ARCHITECTS DESIGN STATEMENT

RESIDENTIAL DEVELOPMENT

**HAYDEN'S LANE, LUCAN, CO. DUBLIN
(SDDC Plan Ref: SD21A/0369)**

Response to “Clarification of Additional Information”

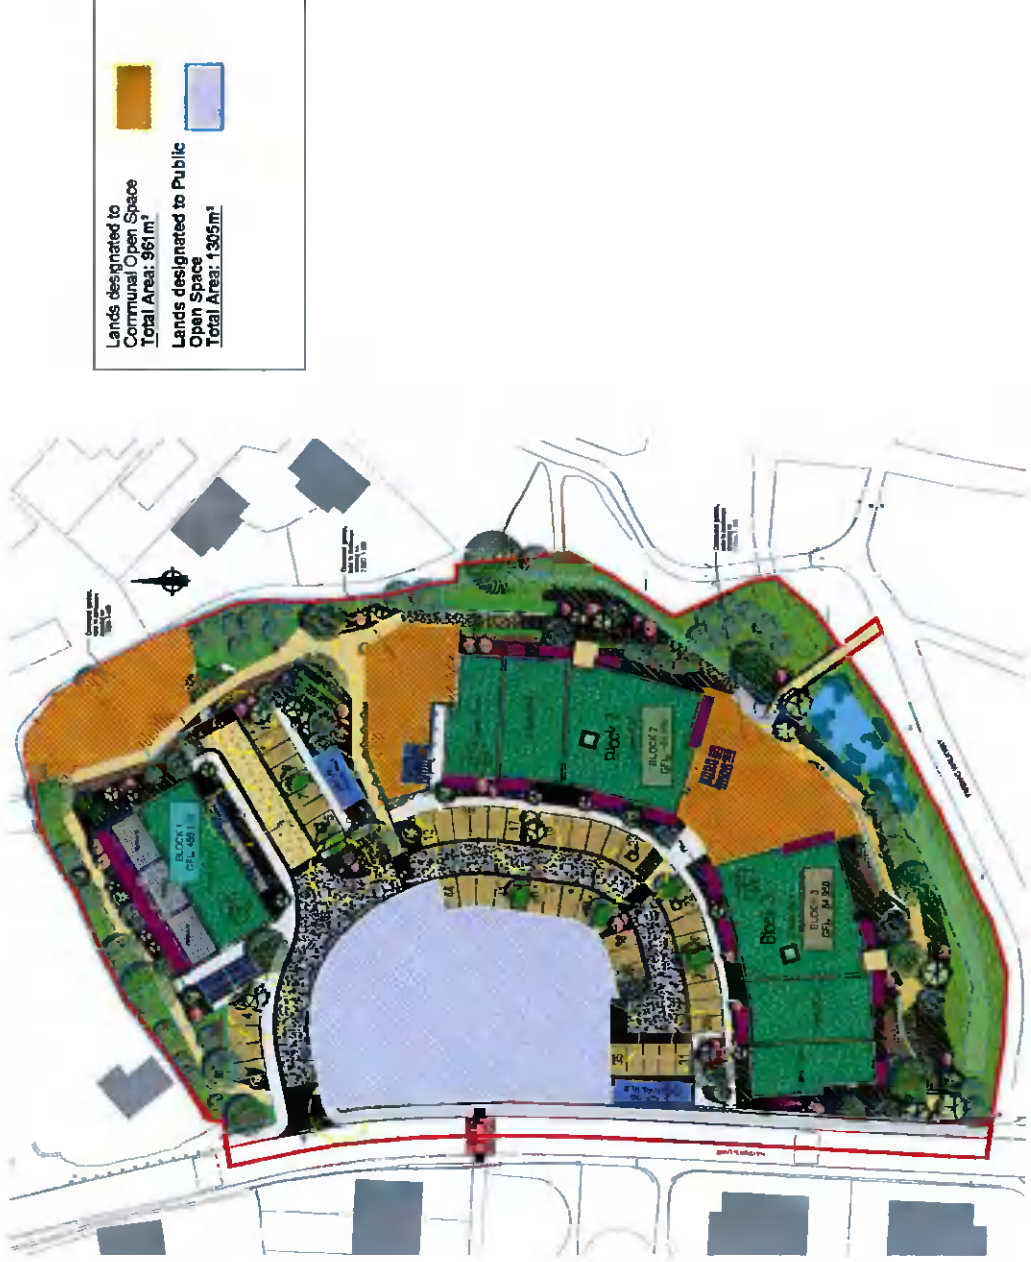
In relation to Additional Information Item 1, the applicant is requested to submit;

- a) Revised documentation and drawing(s) (Proposed Site Plan– Area designation) indicating the total useable communal open space.

Below is a table indicating the mix of units across the 3 No. blocks in the proposed development. The Communal Open Space required is noted as is the Communal Open Space achieved. The space achieved exceeds the space required. This is indicated on Oppermann Associates drawing No. 006 - 6 No. A3 size copies are included with this submission

Block 1 - Clarification of Further Information Elevation

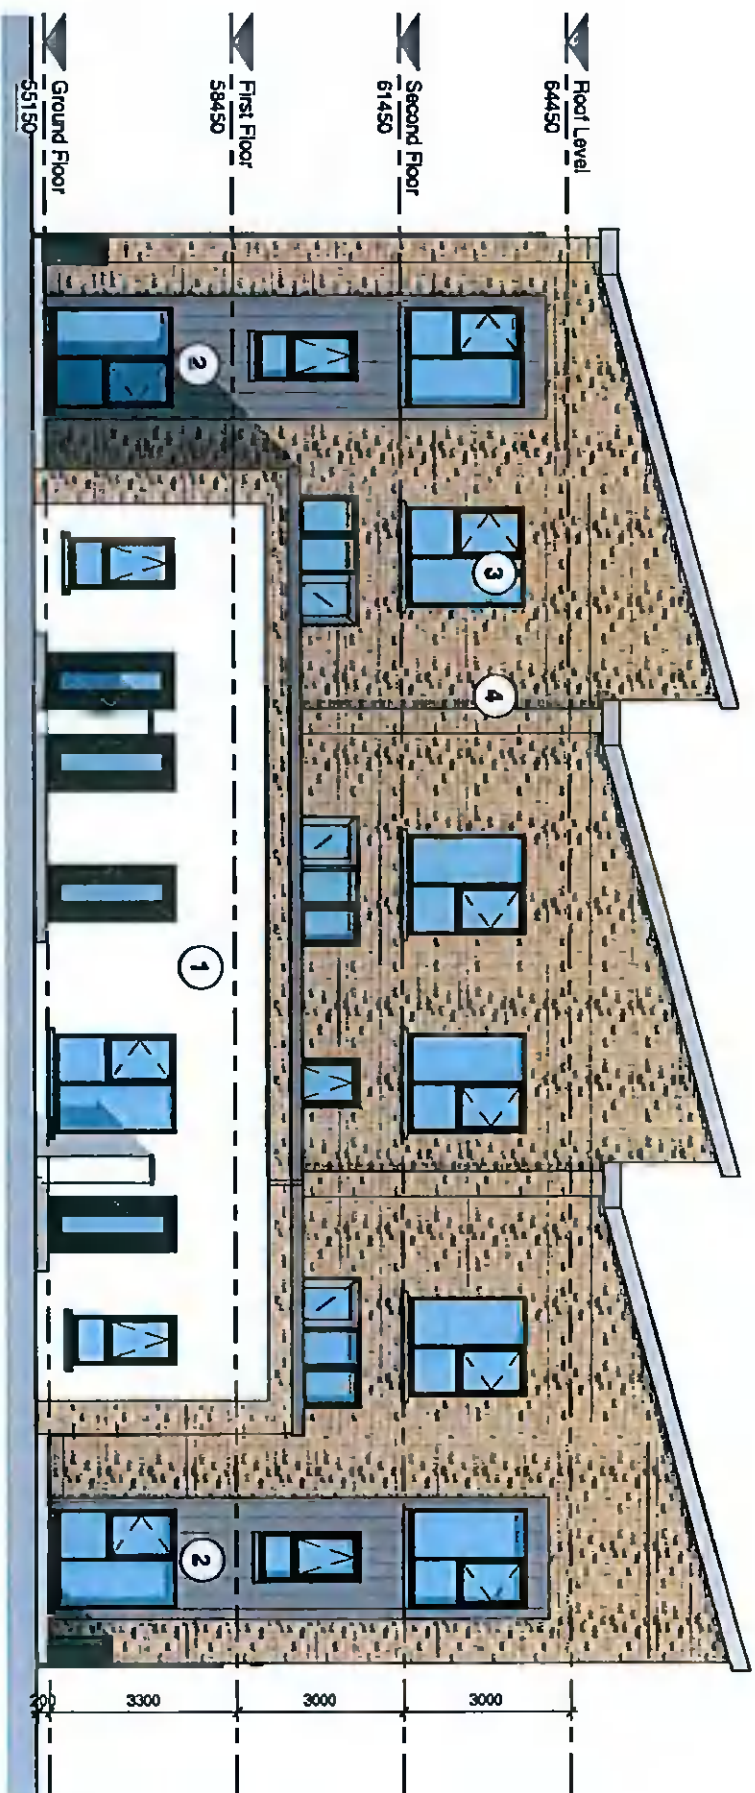
The Planning Authority still has concerns in relation to the impact of the proposed development on residential and visual amenity. The amendments and information submitted under Additional Information Items 3 and 6 are not considered sufficient to address these concerns. The applicant is required to submit a revised proposal to improve the blocks design and reduce their bulky and monolithic appearance. Some suggested amendments for improving the design include:

- Omitting the use of glazing on balconies.
 - Introducing further vertical articulation and elements (bays etc.)
 - Providing a setback at the upper floor.
 - Changing window orientations and shapes.
 - Increasing the depth of window reveals.
 - Variation of brick bonding type.
- This would help break up the bulkiness of the buildings and create more visual interest.

Vertical emphasis has been added. The elevation has been divided in three with the introduction of three mono-pitch roofs and brick pier projections which conceal the rainwater downpipes. There is also a greater sense of individuality.

Verified CGI from the Old Forge Estate

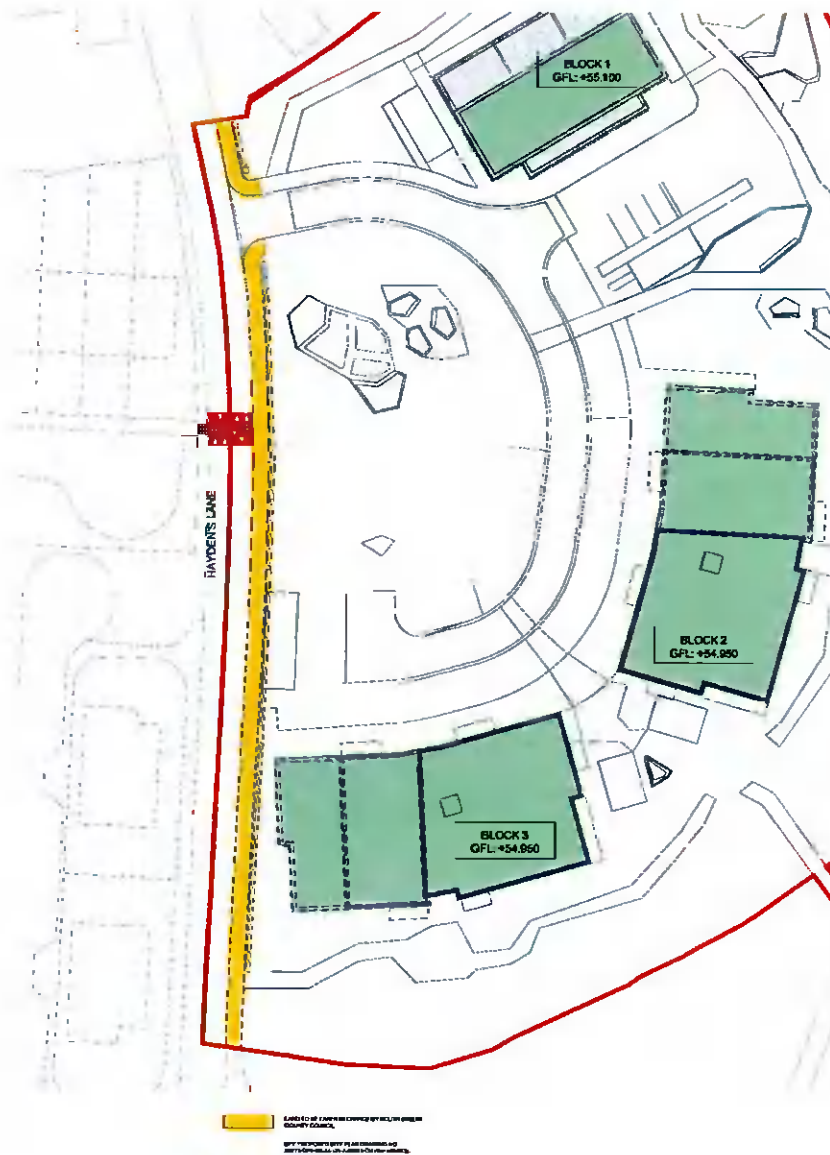
The applicant is also requested to submit additional photomontage(s) of the proposed development when viewed from existing residential development to the east of the subject site, at The Old Forge Estate.

Revised photomontages have been included at A3 size submittal separately.

In addition, as requested, an additional photomontage of the proposed development viewed from the Old Forge Estate is now also included
